OLIN CORPORATION, 425 TENNANT AVENUE, MORGAN HILL, SANTA CLARA COUNTY

Subject: Olin Response to Central Coast Water Board Comments
SLIC: 425 Tennant Ave, Morgan Hill
Second and Third Quarter 2006 Groundwater Monitoring Reports,
and East of Site Characterization Report
MACTEC Project No. 6100070002-09.07

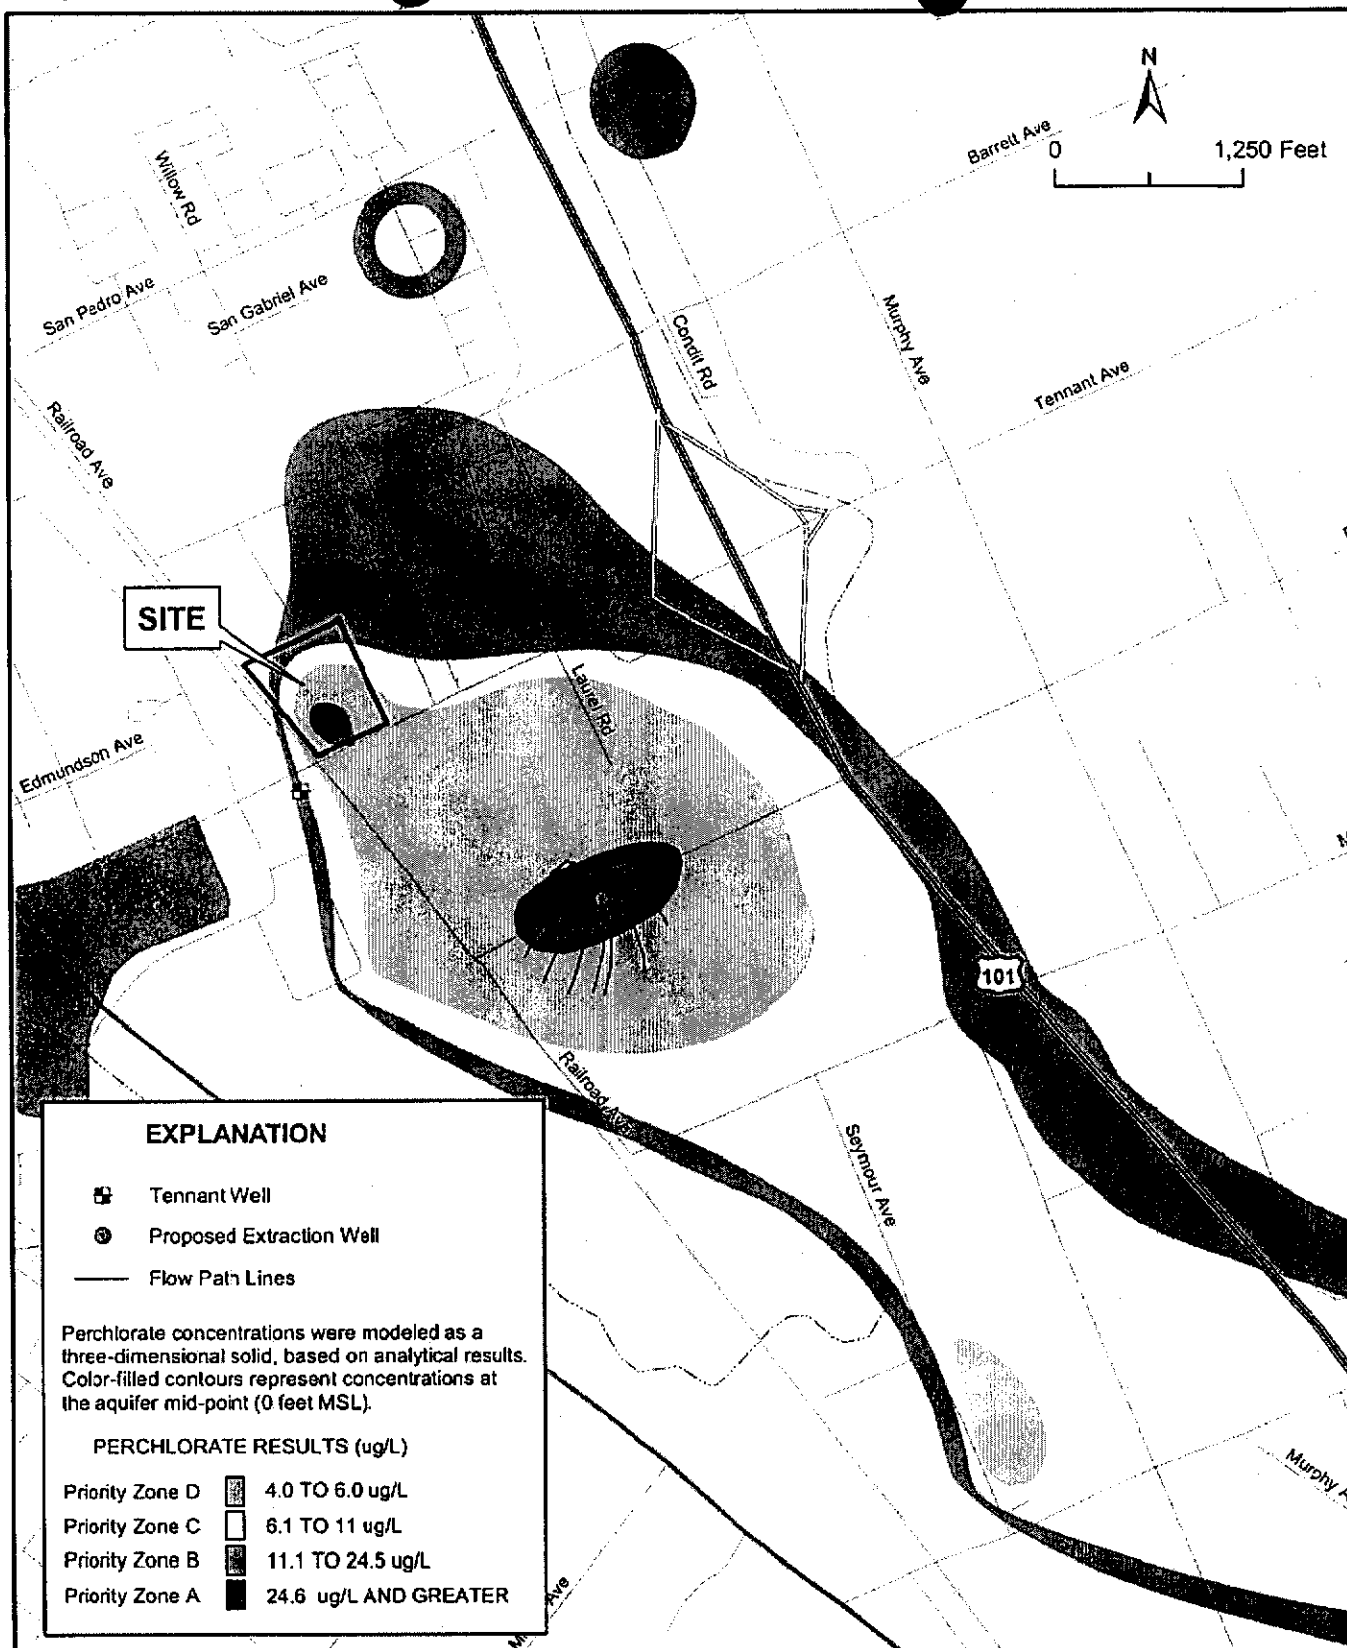
Comment 2. Provide an analysis of how the Tennant Well pumping affects perchlorate distribution and capture zones in the intermediate and deep aquifer zones. The analysis should evaluate if the Tennant Well is pulling the perchlorate plume downward, and to what extent the Tennant Well is providing hydraulic containment of the perchlorate plume in the intermediate and deep aquifer.

Response: In a letter dated May 13, 2003, Olin Corporation stated that operation of the Tennant Well should not resume because of concerns regarding the potential for downward migration of perchlorate into the deep aquifer. Despite these concerns, the City of Morgan Hill elected to resume pumping and perchlorate concentrations have and continue to increase at MW-04C and MW-05C.

Time-concentration plots for deep monitoring wells MW-04, MW-05, and MW-06 prior and subsequent to the November 2004 restart of the Tennant Well are illustrated on Figure 1. These data illustrate that, while an increase in perchlorate concentrations at well MW-06C did not occur until well after the resumption of Tennant Well pumping, subsequent increases in concentration at wells MW-04C and -05C were immediate. These perchlorate concentration increases in the deep aquifer appear to have been a direct result of Tennant Well operation. Where prior to operation of the Tennant Well perchlorate concentrations were primarily less than the 6 µg/L PHG, perchlorate concentrations increased subsequent to operations and appear to have followed an increasing trend. Based on the increasing trend in concentrations at these two wells, continued operation of the Tennant Well is likely to result in concentrations higher yet in the deep aquifer beneath the Site. As a result, continued operation of the Tennant Well is likely to address perchlorate concentration that, as a result of Tennant Well operation, now exceed the PHG.
